### Proposed Revisions to a Standard Plans Index

Index Number: 521-611

Sheet Number (s): 2 of 4

Index Title: Concrete Barrier/Junction Slab - Wall Coping (FRP)

TYPICAL SECTION THRU PRECAST 36" SINGLE-SLOPE CONCRETE BARRIER AND COPING WITH C-I-P JUNCTION SLAB

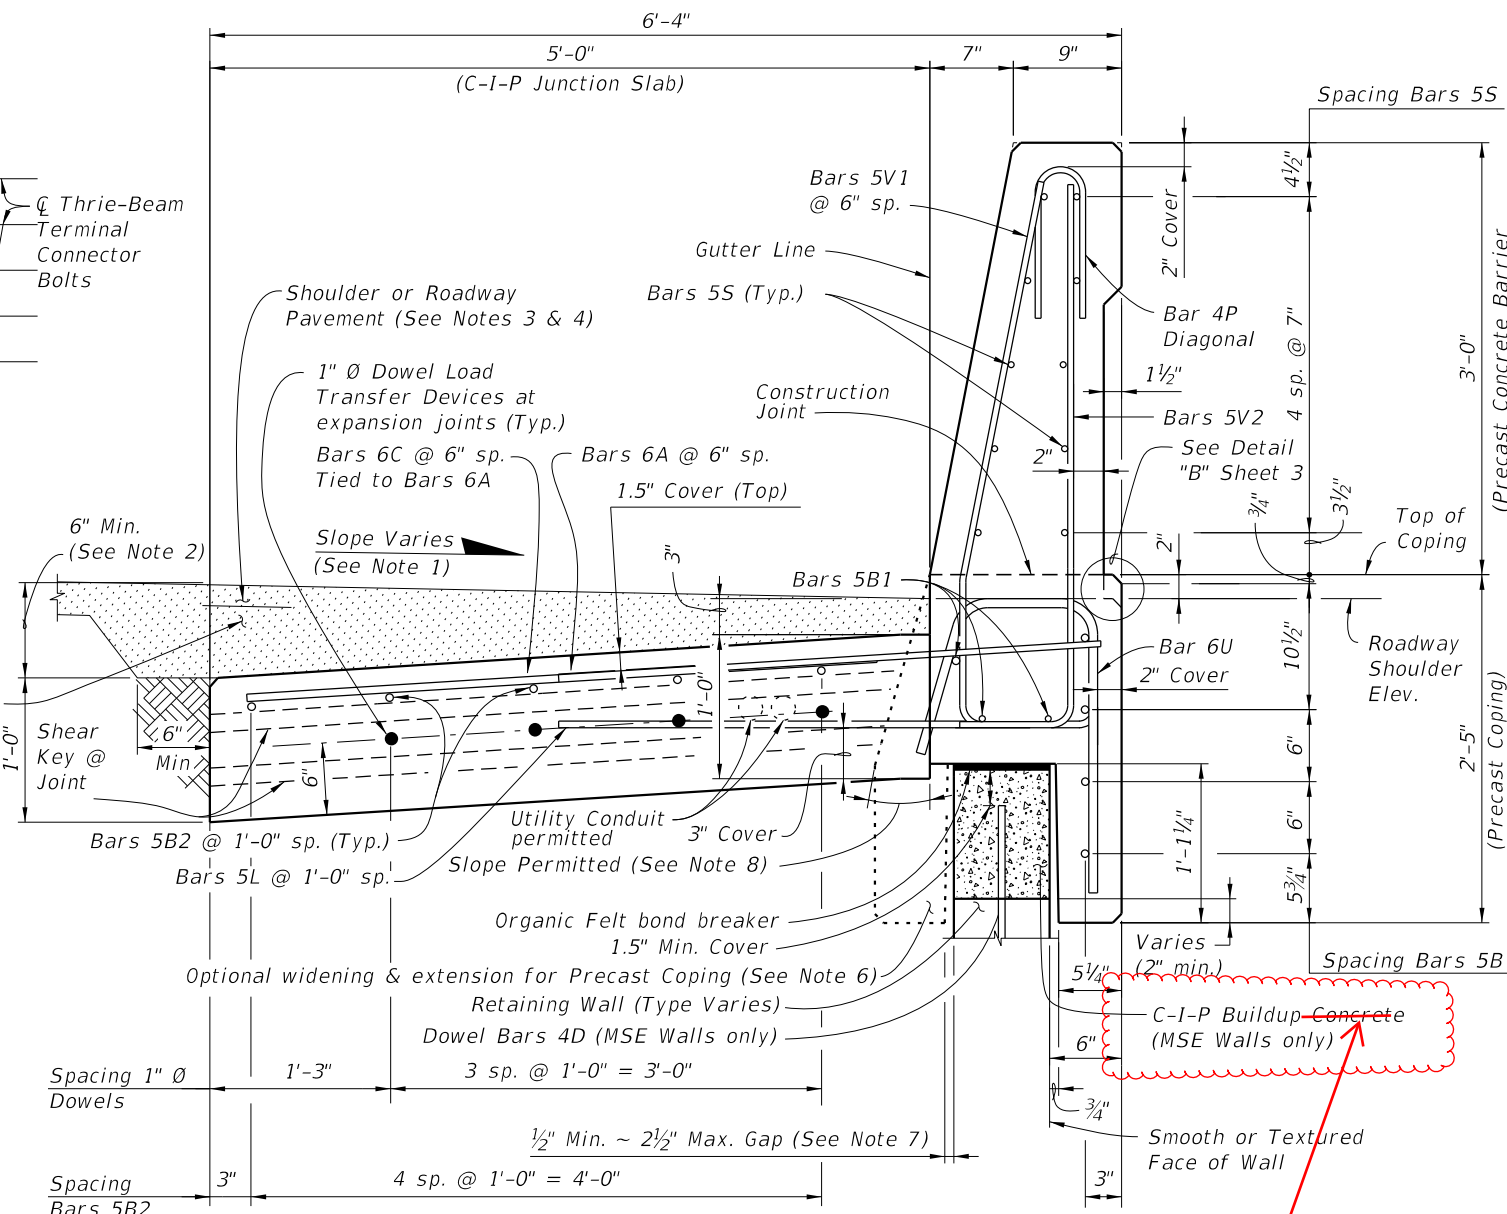
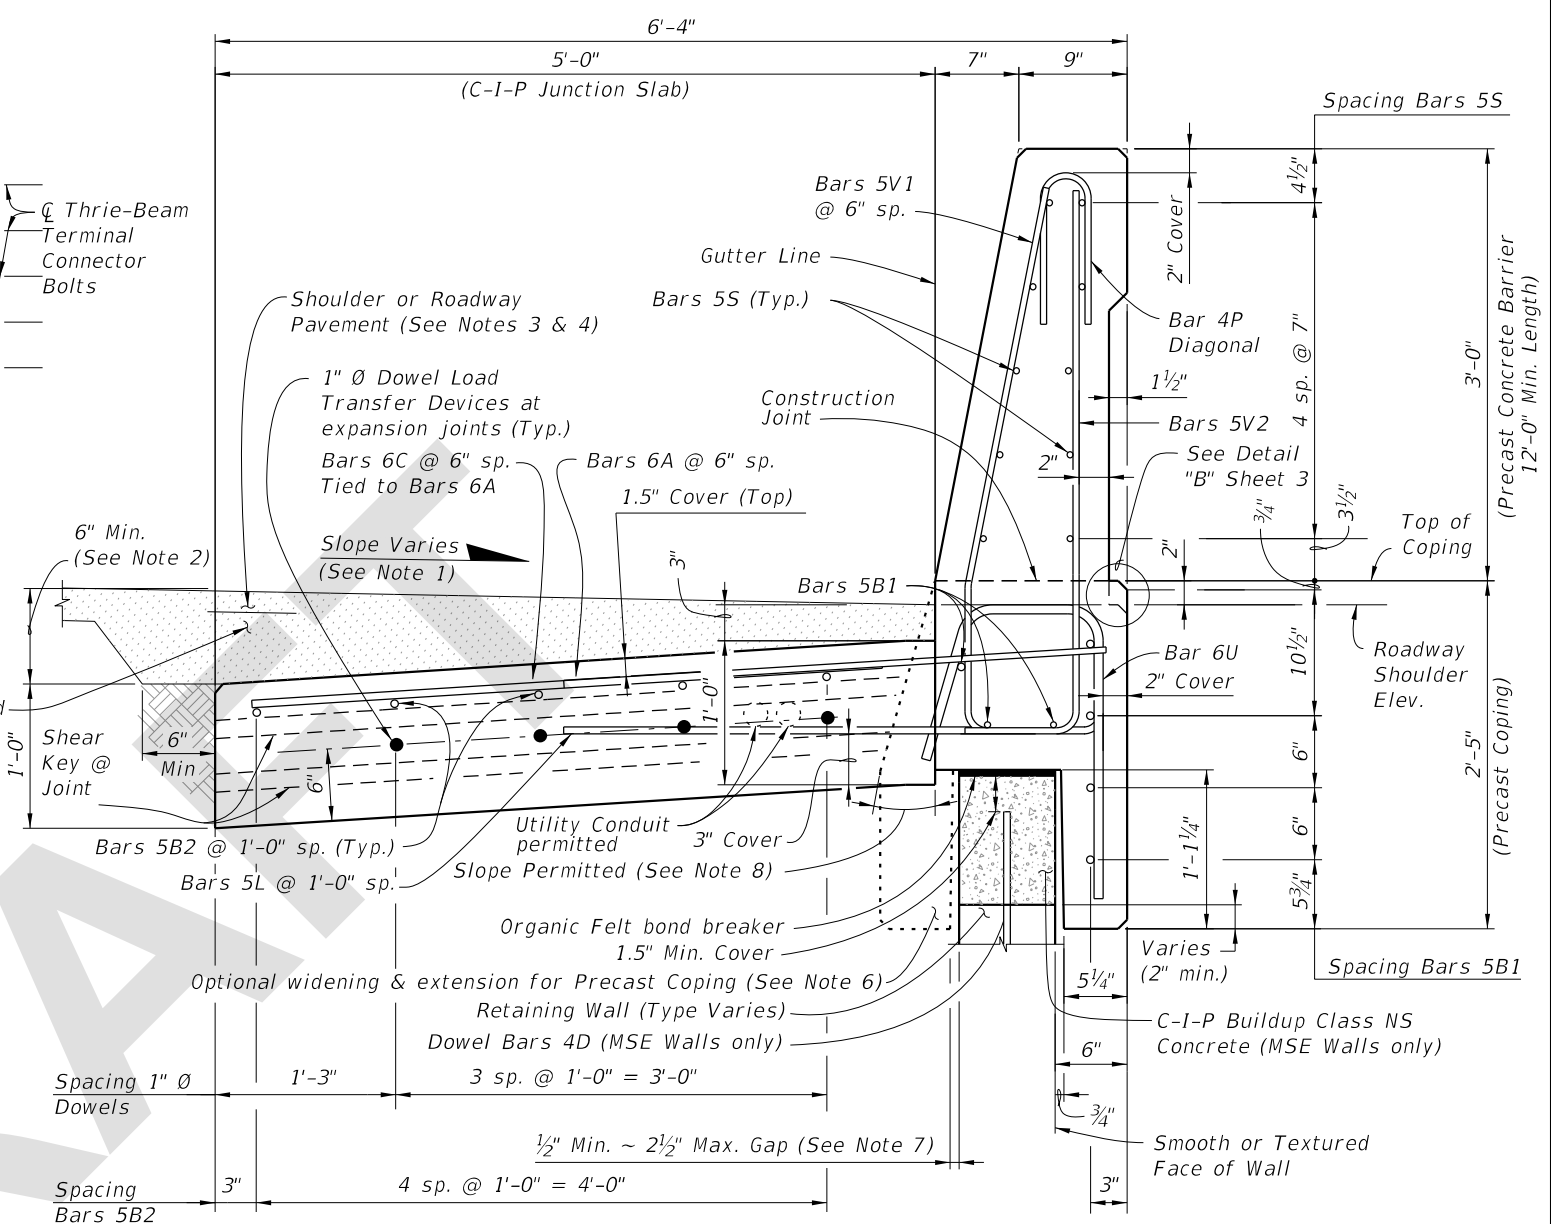
Changed C-I-P Buildup Concrete (1'-1" Max.) callout in the TYPICAL SECTION THRU PRECAST 36" SINGLE-SLOPE CONCRETE BARRIER AND COPING WITH C-I-P JUNCTION SLAB to C-I-P to Class NS Concrete (1'-1" Max.).

CIP buildup concrete type was never clarified. SDO review deems Class NS is acceptable because the concrete buildup section is not meant to transfer any meaningful load to the wall other than self weight.

CHANGED TO: Class NS Concrete
